19. PROBABILISTIC RISK ASSESSMENT
AND SEVERE ACCIDENT EVALUATION

US-APWR Design Control Document

Section 9.2 Change List

Note : This is excerpt from Tier 2 Ch.9 Change List as of 7/29/2011 and will be finalized in the 1st Tracking Report of DCD Rev.3.

Figure 19.1-2 Simplified System Diagram (Sheet 14 of 42) (Component Cooling Water System [1 of 5])

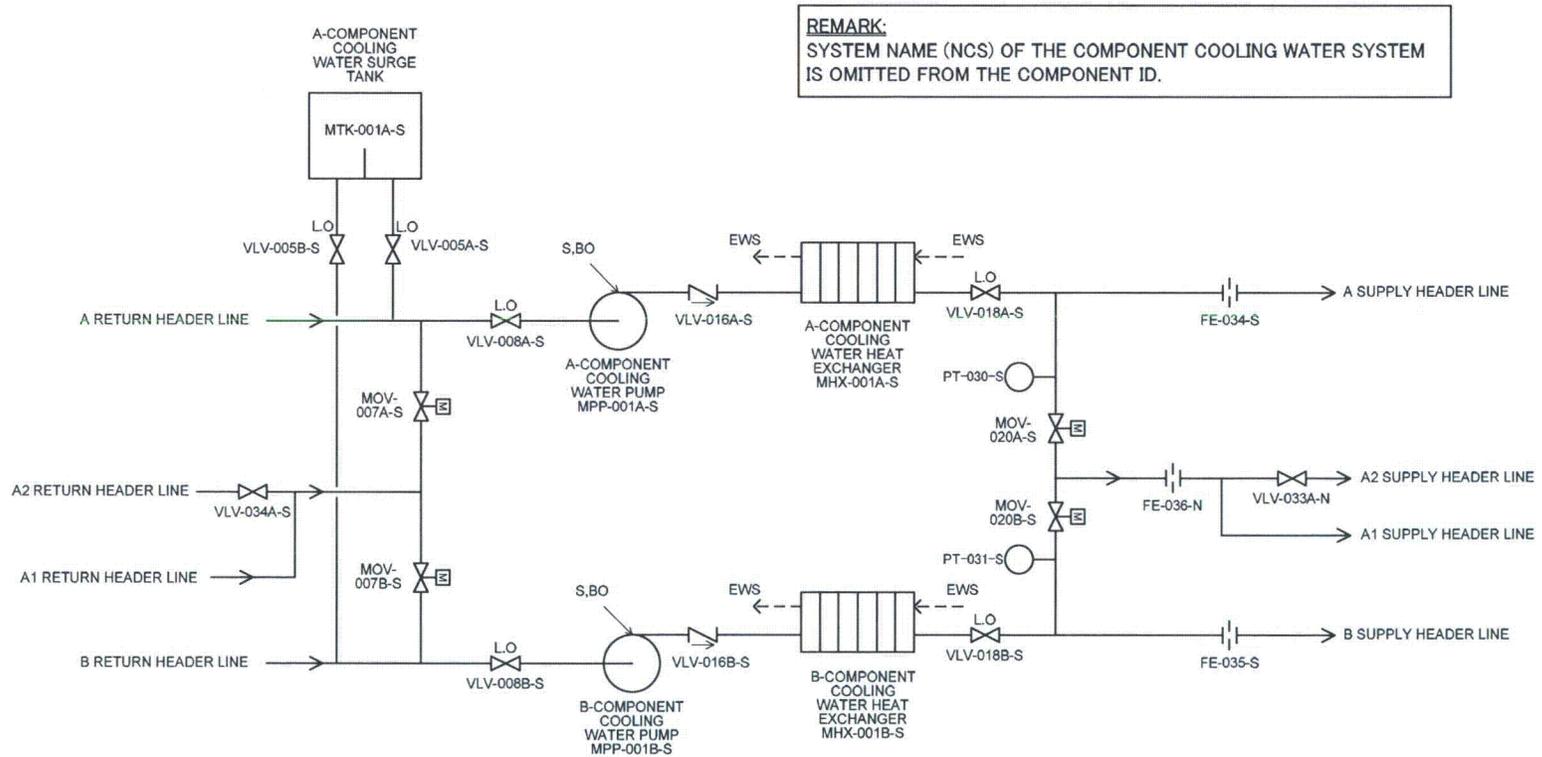
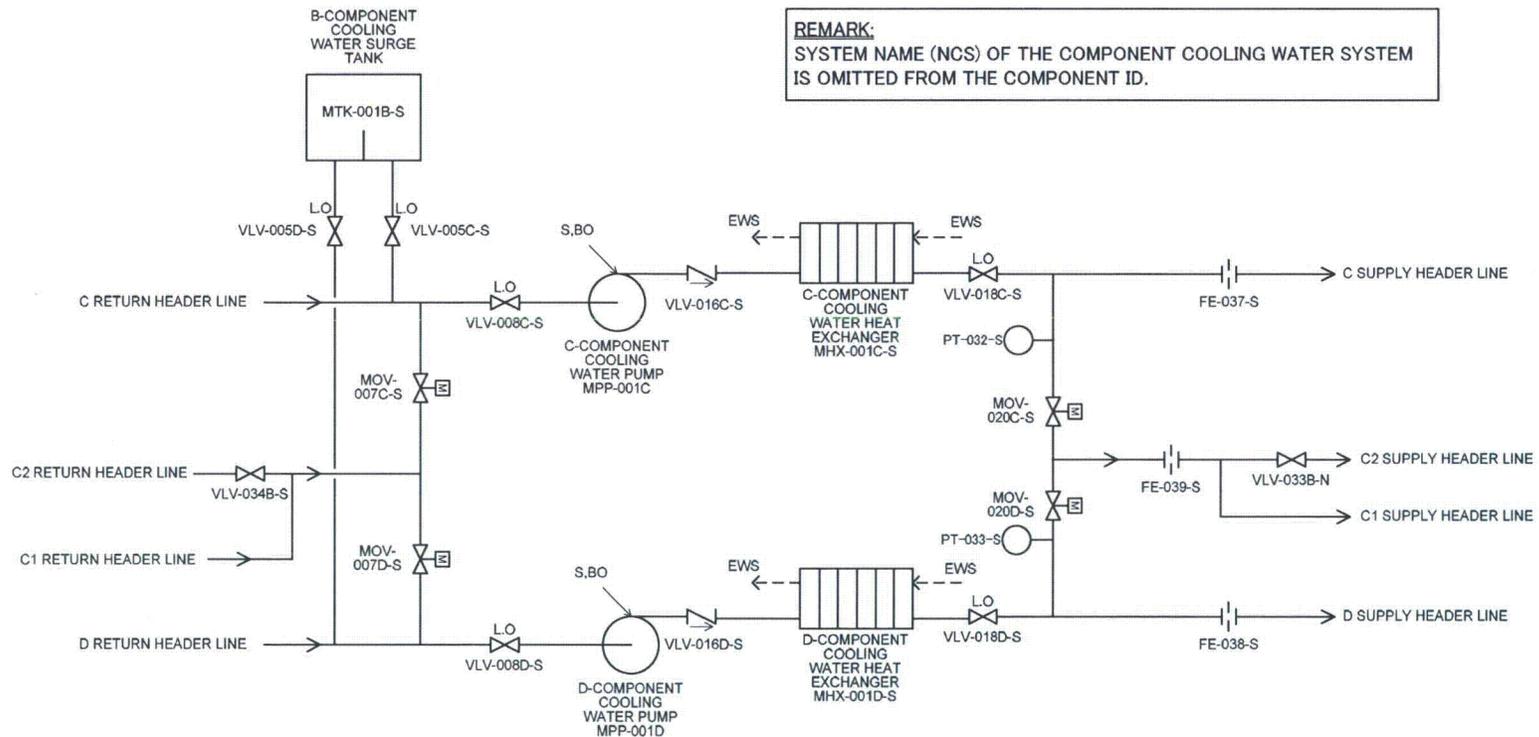
DCD_09.02.
02-48

Figure 19.1-2 Simplified System Diagram (Sheet 15 of 42) (Component Cooling Water System [2 of 5])

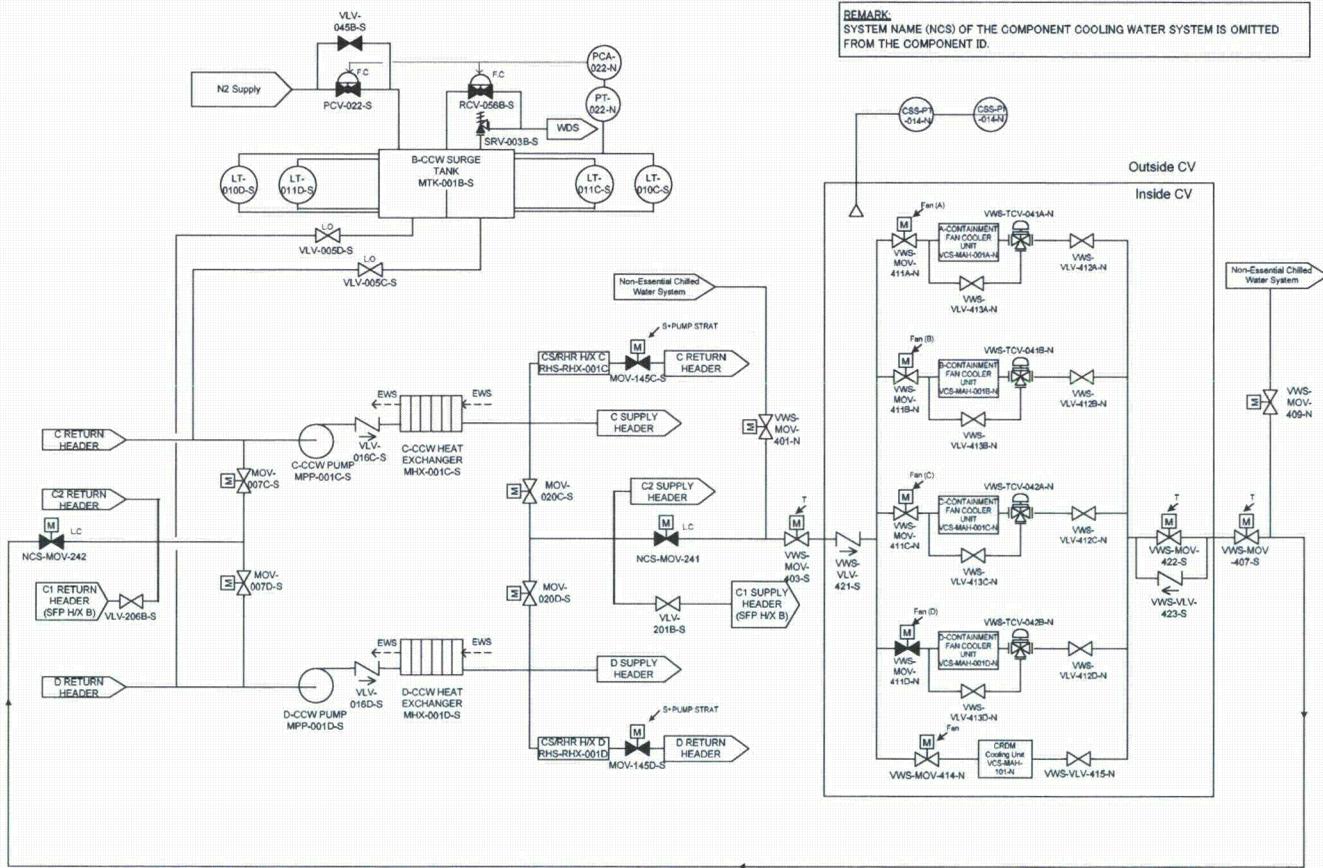
DCD_09.02.
02-48

Figure 19.1-2 Simplified System Diagram (Sheet 28 of 42)
(Alternate Containment Cooling by Containment Fan Cooler System - Normal Operation)

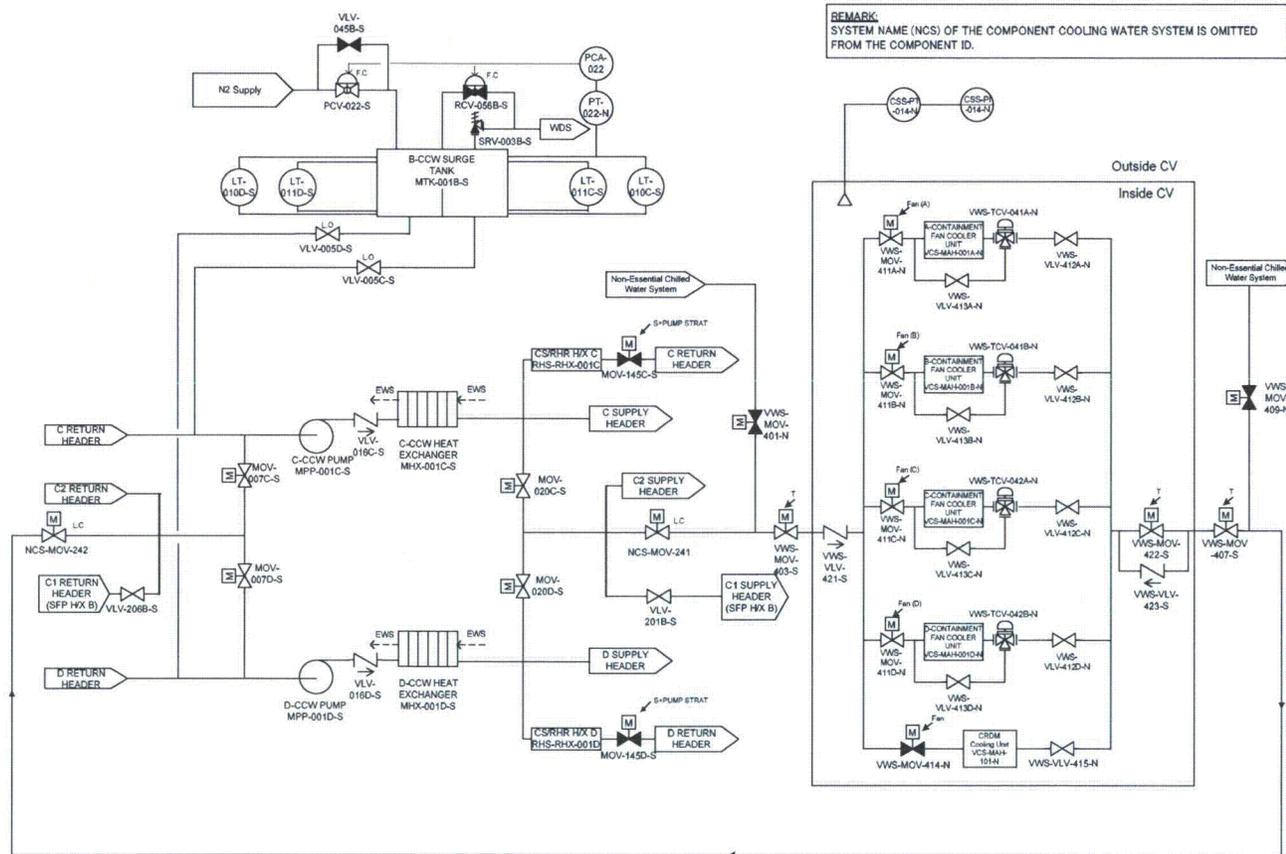
DCD_09.02.
02-80

Figure 2.7.3.3-1 Component Cooling Water System (Sheet 1 of 2)

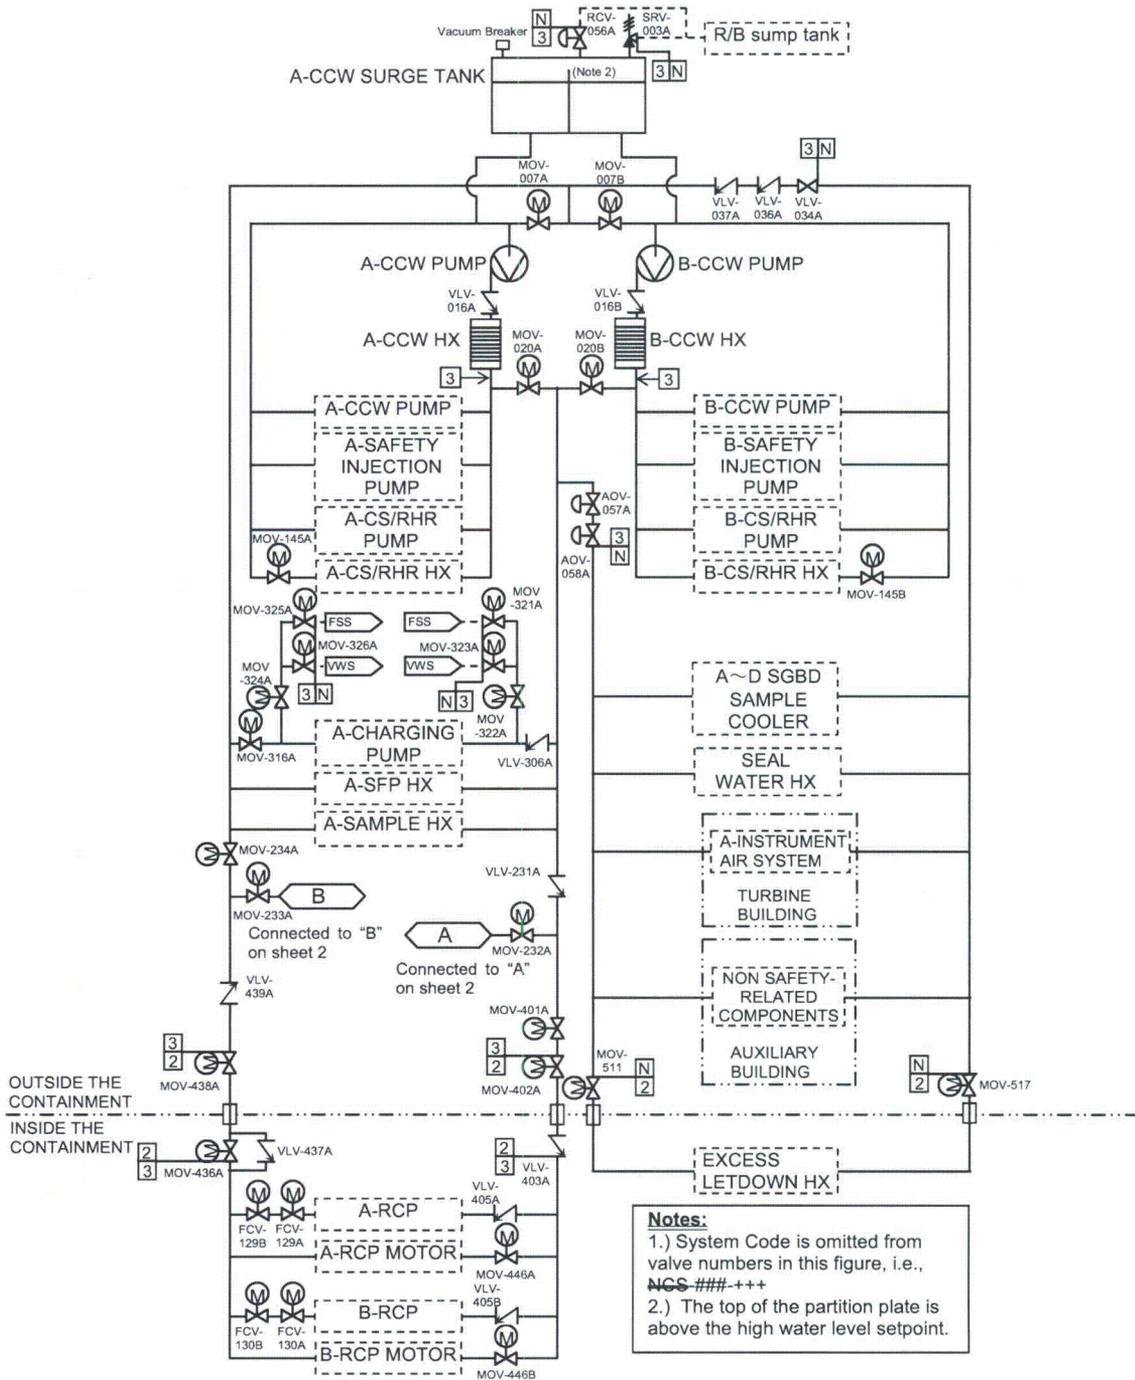
DCD_09.02.
02-49
DCD_09.02.
02-51

Figure 2.7.3.3-1 Component Cooling Water System (Sheet 2 of 2)

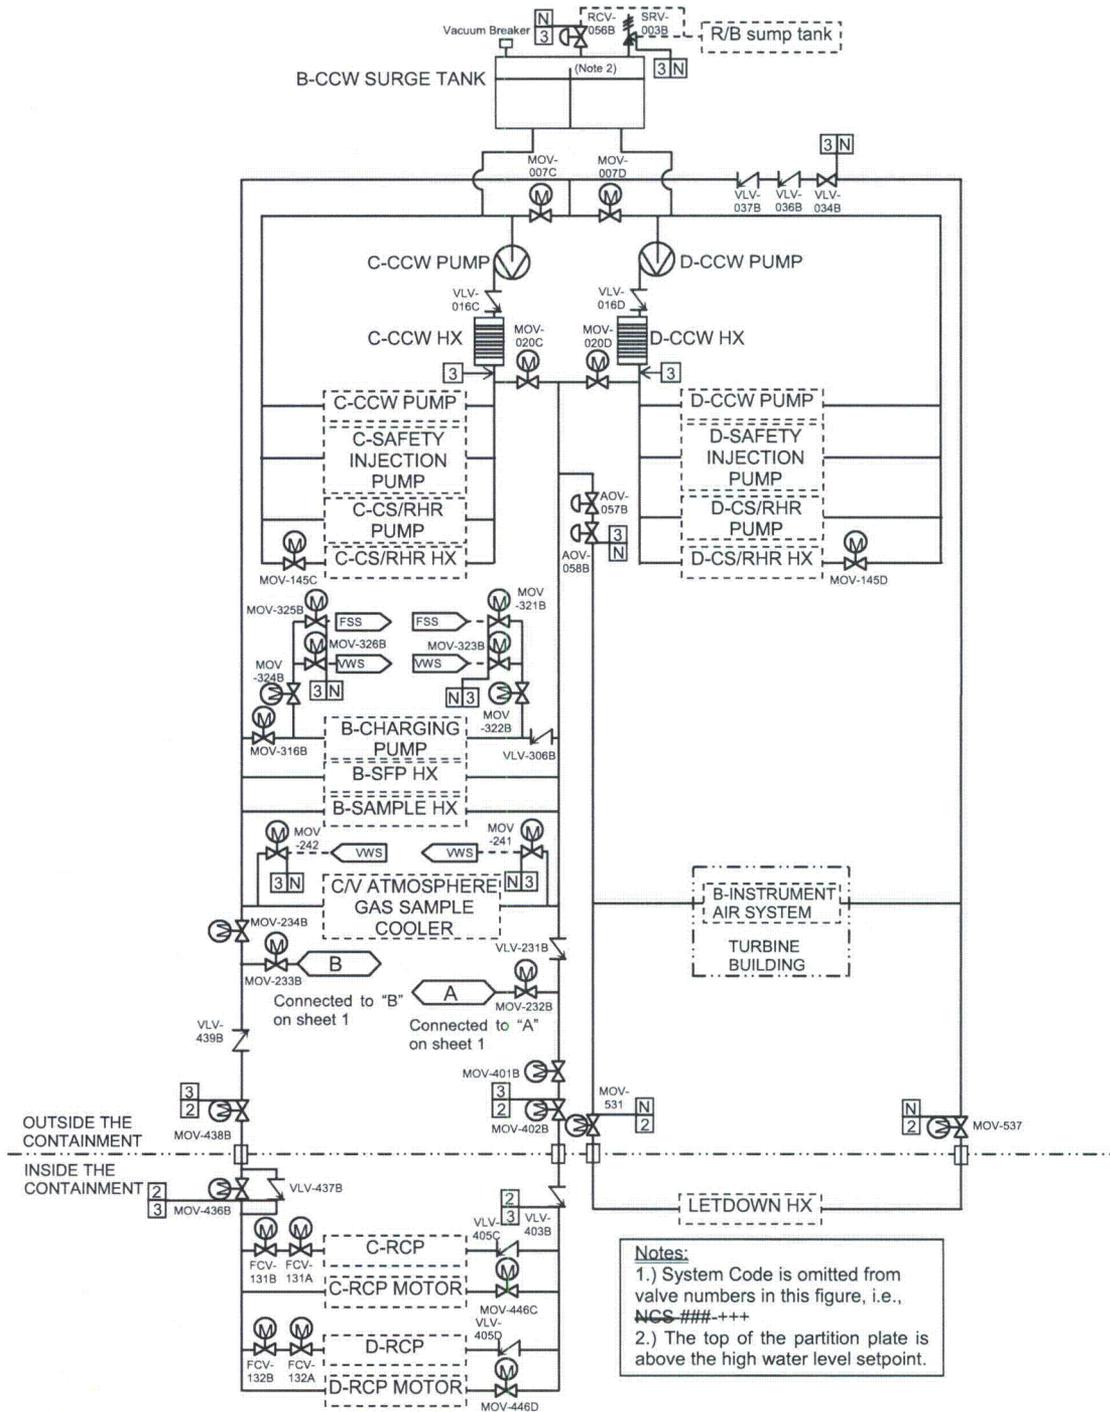
DCD_09.02.
02-49
DCD_09.02.
02-51

Figure 2.7.3.6-1 ~~Non-Essential Chilled Water System~~ Deleted

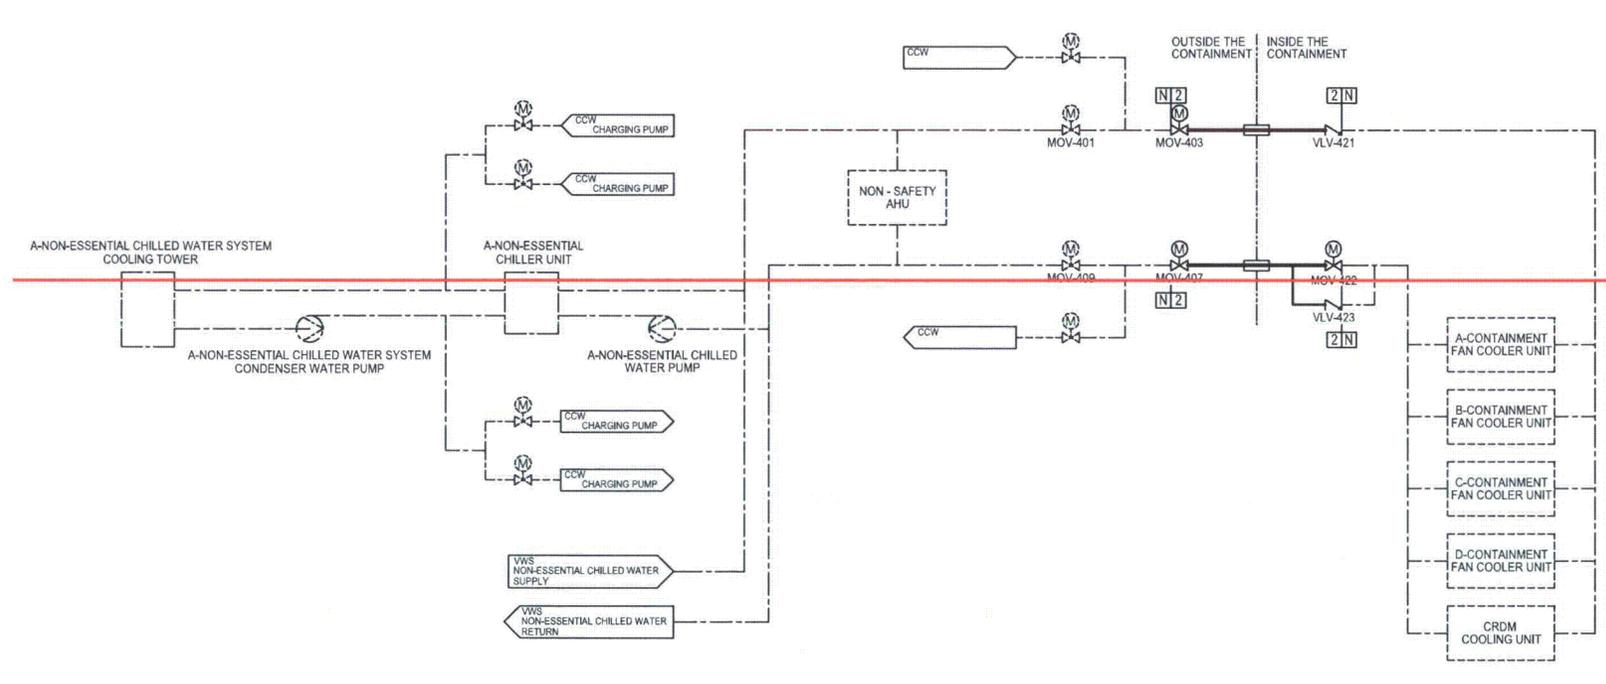
DCD_09.02.
02-76
